New drum brake lining GIGANT 150 for wheel brake 4218

Series launch 10/2023

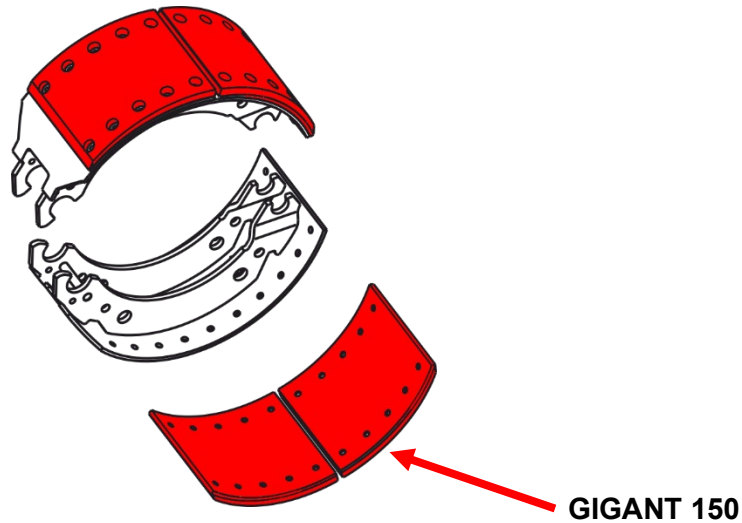
In collaboration with our friction lining supplier, GIGANT developed and validated the material GIGANT 150. The lining was tested according to ECE R13 as well as according to various in-house testing criteria.

- Tested according to ECE R13
- Stable friction coefficient behaviour throughout the entire lining service life
- Optimised wear behaviour in terms of temperature, pressure and speed

- Please note that within the scope of initial fitting, the new brake linings require updating of the vehicle-specific registration.
- Test protocol 361-015-07 suffix02 can now be downloaded from the GIGANT homepage: <https://www.gigant.com/service/pruefprotokolle/> or requested via homologation@gigant.com.
